Charlotte Historic District Commission

Agenda Supplement

August 13, 2025

Applicant/Staff Provided Information

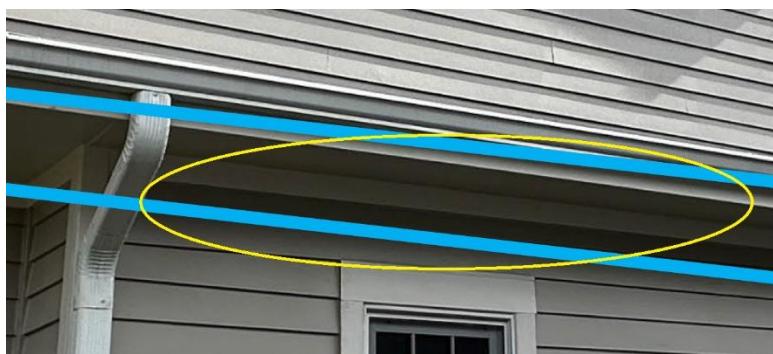
Page 2 section 4,a. – this dimension was not provided but is assumed to be the same as the left elevation at 23'-8". (see page 12 of the presentation)

Page 2 section 4, b. – the frieze band is not missing. See image below.

APPROVED

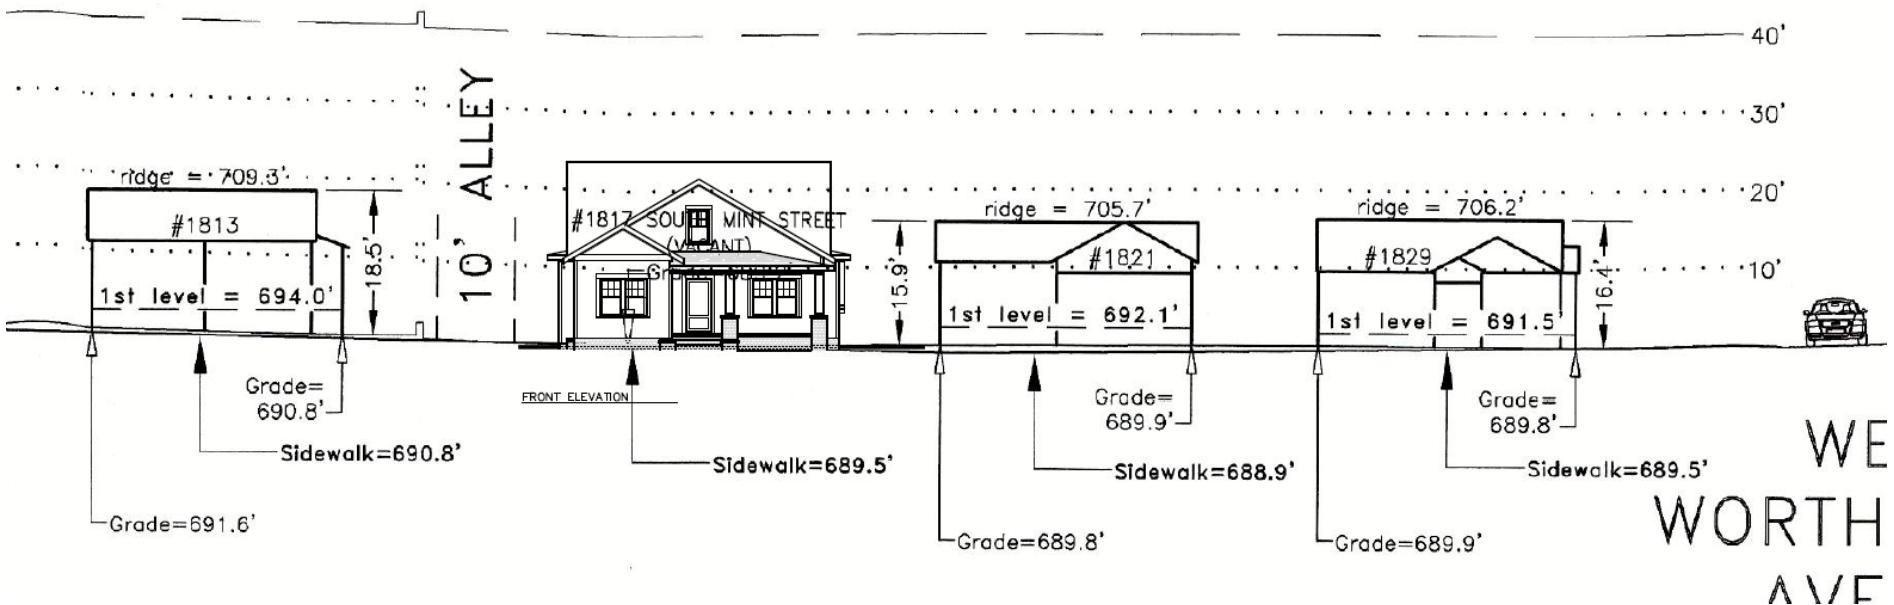
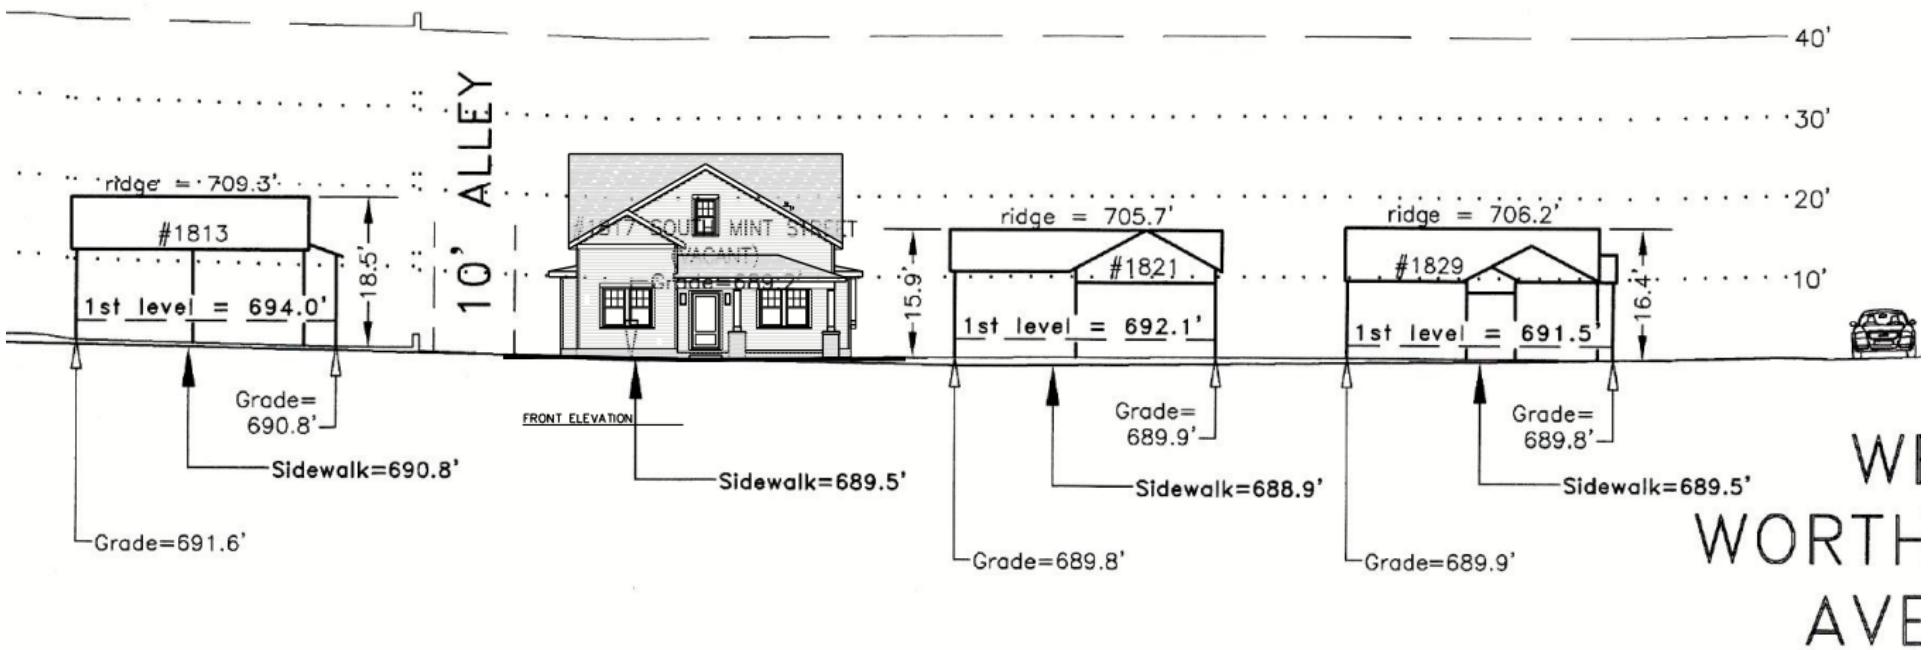
Page 2 section 2, d. – this dimension was provided on our approved, existing, proposed document. It's 18'1" (see page 12 of the presentation)
